# UNITED STATES PATENT AND TRADEMARK OFFICE

APPLICATION NO.	FILING DATE	FIRST NAMED INVENTOR	ATTORNEY DOCKET NO.	CONFIRMATION NO.
10/507,233	06/17/2005	Carmen Grande	4069-045138	1780

<b>Office Action Summary</b>	<b>Application No.</b> 10/507,233	<b>Applicant(s)</b> GRANDE, CARMEN	
	<b>Examiner</b> Mark A. Williams	<b>Art Unit</b> 3676

## **DETAILED ACTION**

fig 2

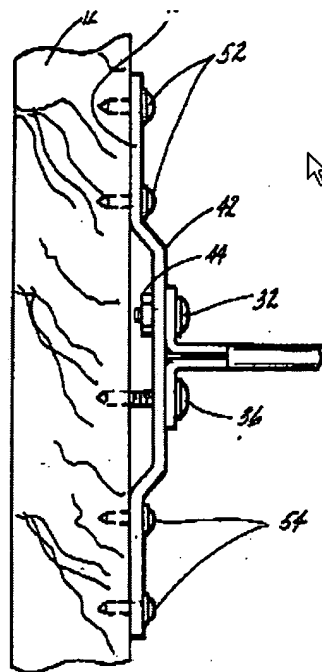
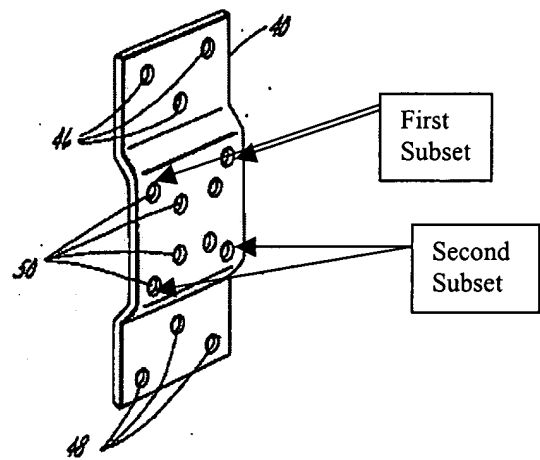
See the below figure. Whaley provides a door piston to doorjamb interface apparatus comprising an elongated plate 40 having a plurality of holes 50 formed therein; and a bracket 18 including a base and transverse support member affixed to the base, the base including a set of holes configured in the same pattern as a subset of the plurality of threaded holes of the plate whereupon, when the set of holes and the subset of threaded holes are aligned, a threaded bolt inserted through each of the set of holes thereby securing the base to the plate, wherein the support member defines a pin receiving hole 22 that is spaced from the base and which is configured to receive a pin there through for pivotally securing a connecting rod 20 or a housing of a door piston to the support member. The subsets are positioned

intermediate the ends of the plate. Each hole is also configured to pass a threaded wood screw there through in non-threading relationship therewith, and when the plate is positioned against a door jamb, at least one hole can have a wood screw passed in non-threading relationship there through where after said wood screw can be screwed into the door jamb thereby securing the plate to the door jamb (see figure 2 at element 36). The support member defines a gap having a pair of aligned pin receiving holes on opposite sides thereof; the end of the connecting rod or the housing defines a hole configured to be aligned with the pair of pin receiving holes when said end is received in the gap (as conventional in the art); and the pin is configured to be received through the pin receiving holes and the hole in the end of the connecting rod or the housing when said end is received in the gap. The plate has a rectangular shape.

Whaley provides the claimed invention except teaching the plurality of holes being threaded, and a threaded bolt inserted through each of the set of holes can threadedly mate with the subset of threaded holes thereby securing the base to the plate, as claimed. However, it is very old and well known in the art of connectors to use such threaded holes to firmly join two threaded members together with ease of assembly. Hamilton provides threaded holes receiving screw means. It would have been obvious at the time the invention was made for one skilled in the art to

Applicant should note in view of the above figures, that the examiner is now viewing the plurality of holes of Whaley to be the holes 50, and at least two subsets are shown. As seen in figure 2, and as provided in Whaley's disclosure, bolts 32 and 34 secure the support to the plate, and screws 36 and 38 at least partially

secure the support and the plate to the jamb. This arrangement meets the claimed limitations.
